PRODUCT CHANGE NOTIFICATION

SINGL FUSE™ SMD FUSES

Bourns® Model SF-xxxxxx, and SF-xxxxxxA-R SinglFuse™ SMD Fuses *Label Content Modification*

SF2313

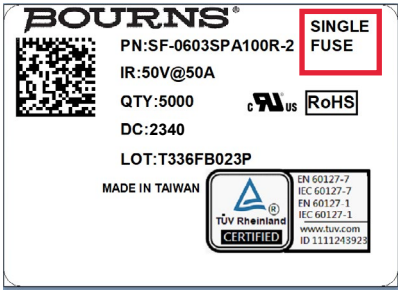
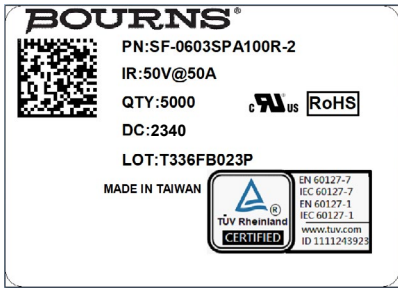
Riverside, California – October 17, 2023 – Effective immediately, Bourns will be removing the term “SINGLE FUSE” from the labels on the taping reels and packaging bags of the [Model SF-xxxxxx](#) and [SF-xxxxxxA-R](#) Series SinglFuse™ SMD Fuses. This adjustment will create consistent label content and a consistent label format across the SinglFuse™ SMD Fuse product line.

Affected Series	Original	New
SF-xxxxxx SF-xxxxxxA-R	 <p>BOURNS® PN:SF-0603SPA100R-2 IR:50V@50A QTY:5000 DC:2340 LOT:T336FB023P MADE IN TAIWAN</p> <p>IEC 60127-7 EN 60127-7 FN 60127-1 IEC 60127-1 www.tuv.com ID 1111243923</p>	 <p>BOURNS® PN:SF-0603SPA100R-2 IR:50V@50A QTY:5000 DC:2340 LOT:T336FB023P MADE IN TAIWAN</p> <p>IEC 60127-7 EN 60127-7 FN 60127-1 IEC 60127-1 www.tuv.com ID 1111243923</p>
